### **Recommendation to Hold a Public Hearing and Approve the Syringa Springs Subdivision: Block 1, Lot 6A Lot Line Shift Final Plat & Findings of Fact, Conclusions of Law, and Decision.**

SYRINGA SPRINGS SUBDIVISION:  
BLOCK 1, LOT 6A

IN RE: )  
)  
Syringa Springs Lot Line Shift ) KETCHUM CITY COUNCIL  
Lot Line Shift ) FINDINGS OF FACT, CONCLUSIONS OF LAW, AND  
Date: December 20, 2021 ) DECISION  
)  
File Number: P21-090 )

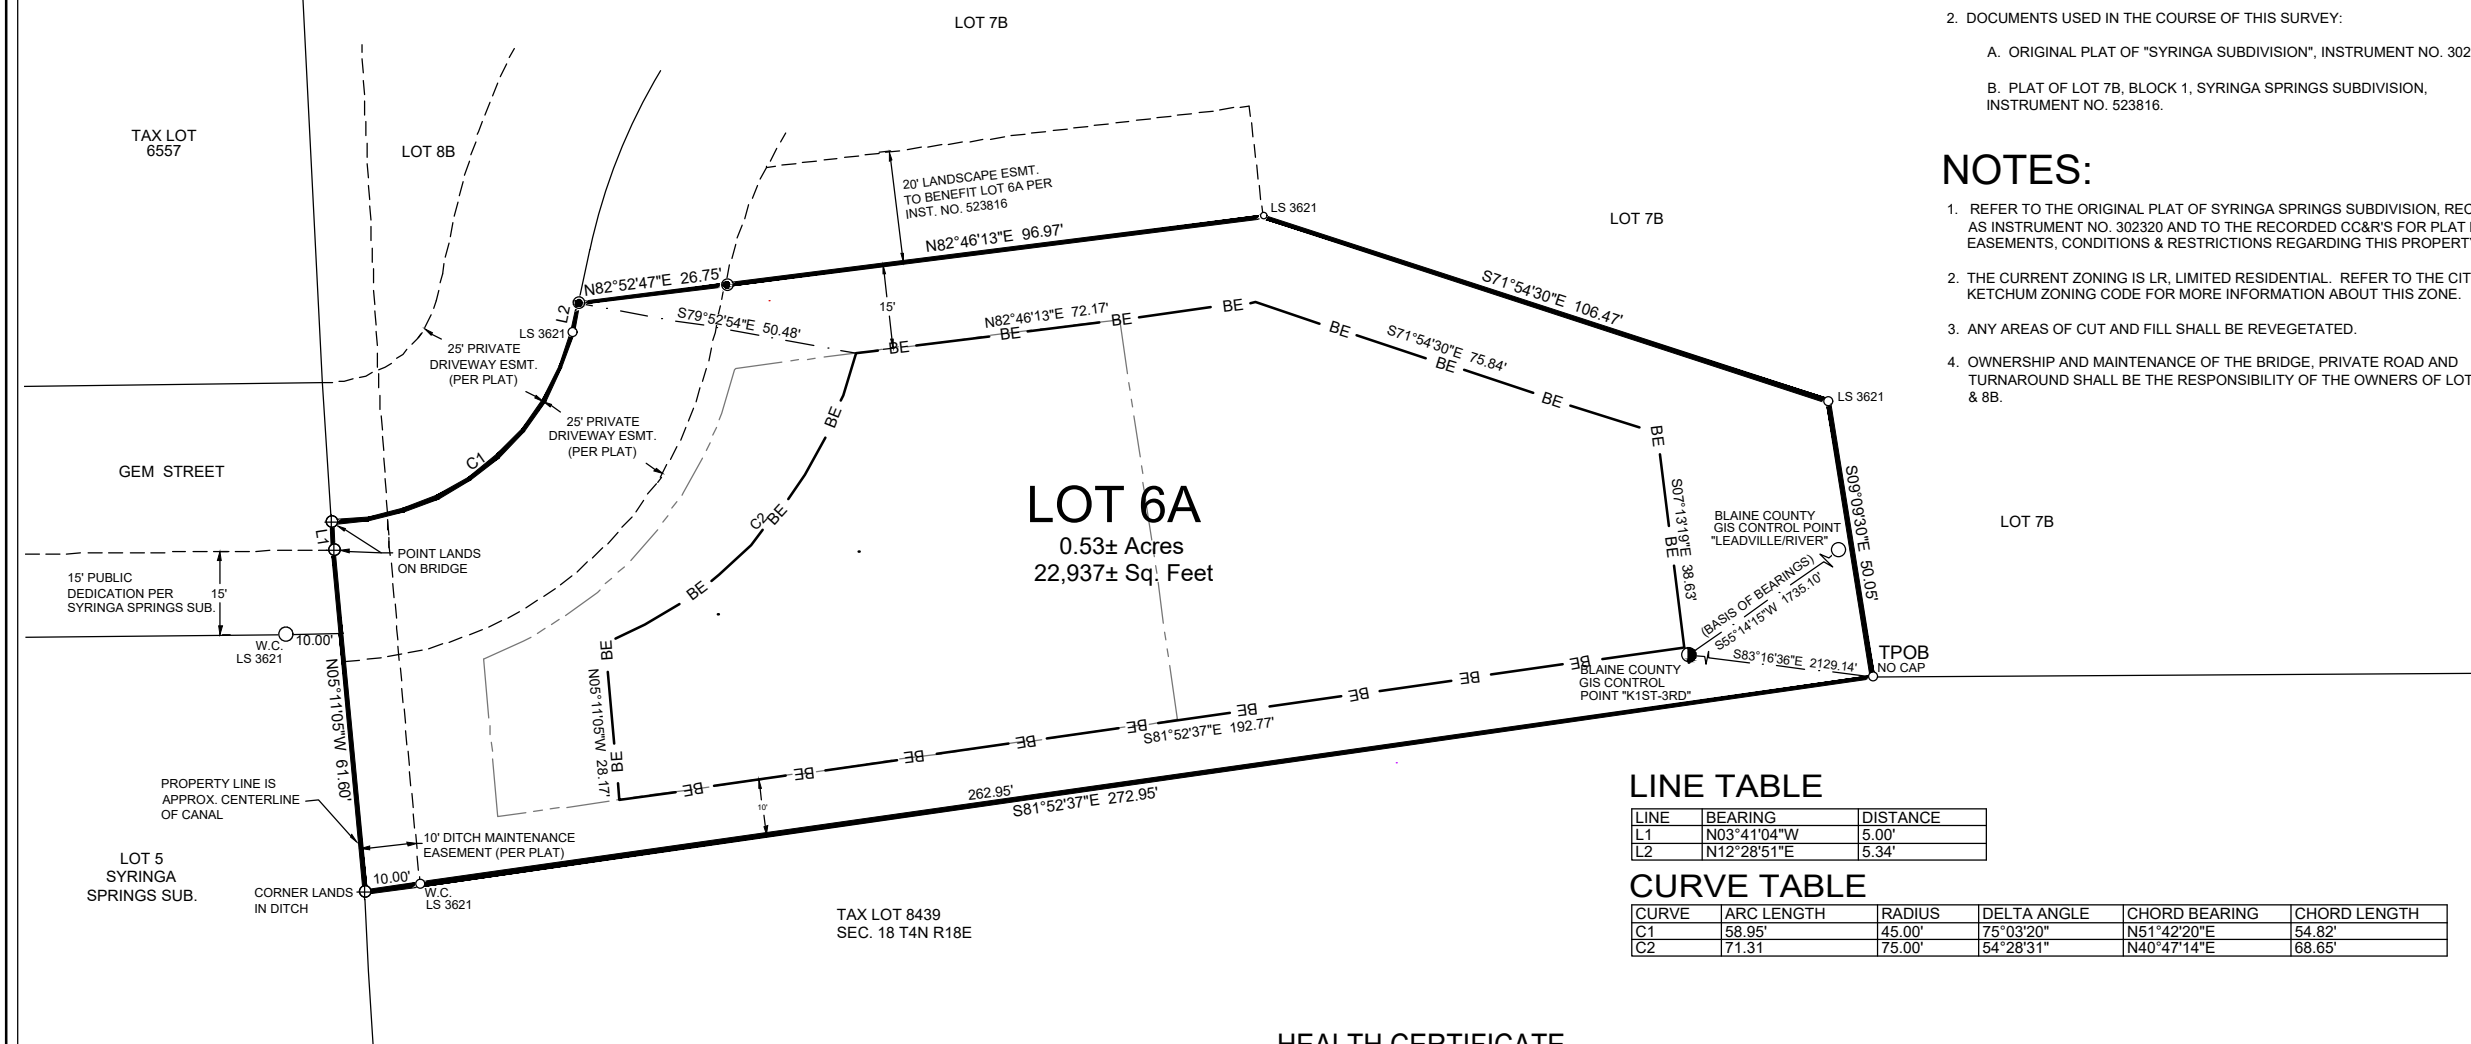
<input checked="" type="checkbox"/>	<input type="checkbox"/>	<input type="checkbox"/>	16.04.030.K.1	<p><b>Point of beginning of subdivision description tied to at least two (2) governmental survey corners, or in lieu of government survey corners, to monuments recognized by the city engineer.</b></p> <p><b>Council Findings</b> <i>As conditioned, this standard shall be met. The plat mylar shall show a minimum of two Blaine County Survey Control Monuments with ties to the property and an inverse between the two monuments. The Survey Control Monuments shall be clearly identified on the face of the map.</i></p>
<input checked="" type="checkbox"/>	<input type="checkbox"/>	<input type="checkbox"/>	16.04.030.K.2	<p><b>Location and description of monuments.</b></p> <p><i>As conditioned, this standard shall be met. The final plat mylar shall show the location and description of monuments.</i></p>
<input checked="" type="checkbox"/>	<input type="checkbox"/>	<input type="checkbox"/>	16.04.030.K.3	<p><b>Tract boundary lines, property lines, lot lines, street right of way lines and centerlines, other rights of way and easement lines, building envelopes as required on the final plat, lot area of each lot, boundaries of floodplain and floodway and avalanche district, all with bearings, accurate dimensions in feet and decimals, in degrees and minutes and radii, arcs, central angles, tangents and chord lengths of all curves to the above accuracy.</b></p> <p><b>Council Findings</b> <i>The plat indicates Gem Street as well as the building envelope and private driveway, ditch maintenance, and public dedication easements.</i></p>

As conditioned, this standard shall be met. The final plat mylar shall show tract boundary lines, property lines, lot lines, street right of way lines and centerlines, other rights of way and easement lines, building envelopes as required on the final plat, lot area of each lot, boundaries of floodplain and floodway and avalanche district, all with bearings, accurate dimensions in feet and decimals, in degrees and minutes and radii, arcs, central angles, tangents and chord lengths of all curves to the above accuracy.
<input checked="" type="checkbox"/>	<input type="checkbox"/>	<input type="checkbox"/>	16.04.030.K.4	<b>Names and locations of all adjoining subdivisions.</b>
			<b>Council Findings</b>	There are no adjoining subdivisions. The plat indicates the adjacent Syringa Springs Subdivision lots and Tax Lot 8439..
<input checked="" type="checkbox"/>	<input type="checkbox"/>	<input type="checkbox"/>	16.04.030.K.5	<b>Name and right of way width of each street and other public rights of way.</b>

3. The recorded plat shall show a minimum of two Blaine County Survey Control Monuments with ties to the property and an inverse between the two monuments. The Survey Control Monuments shall be clearly identified on the face of the map.
